MAJOR REPAIR AND ALTERATION (Airframe, Powerplant, Propeller, or Appliance)

1. Aircraft	Make <p style="text-align: center;">Ryan</p>	Model <p style="text-align: center;">Navion B</p>
	Serial No. <p style="text-align: center;">NAV-4-2313B</p>	Nationality and Registration Mark <p style="text-align: center;">N5413K</p>
2. Owner	Name (As shown on registration certificate) <p style="text-align: center;">Putney, William W III Rodgers, Gail C</p>	Address (As shown on registration certificate) <p style="text-align: center;">5780 Balmoral Drive Oakland, CA 94619</p>

Description of alteration: This alteration removes a Narco Mk-12A NAV/COM, CDI, VOR Resolver, Glideslope Receiver and Power Unit. This alteration also installs a Bendix/King model KX-125 NAV/COMM and a Bendix/King model KI214 VOR/LOC - GS indicator.

N5413K Panel

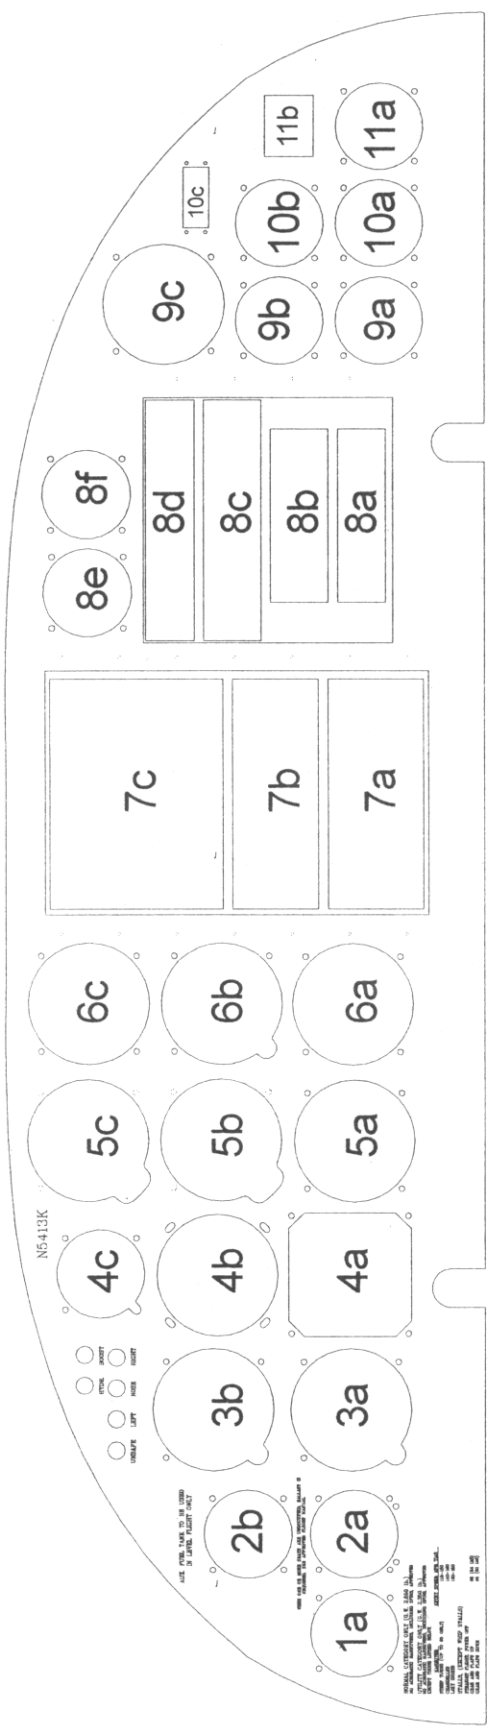
Description of work: The Narco radio and its wiring and accessories were removed and discarded. Installation of the new radio at location 7b and indicator at location 6b (see N5413K Panel dwg attached) were accomplished according to the installation instructions in the Bendix/King "KX 125 Communication Transceiver/Navigation Receiver Installation Manual" (manual number 006-00655-0001) and the King "KI214 VOR/LOC-OBS Indicator Installation Manual (manual number 006-0092-01). 6-#6-32 flathead screws attaché the radio tray to the radio rack. Audio inputs and outputs are provided to the aircraft's audio panel (see attached N5413K Audio drawing). The existing communication and navigation antennas were reused for this installation.
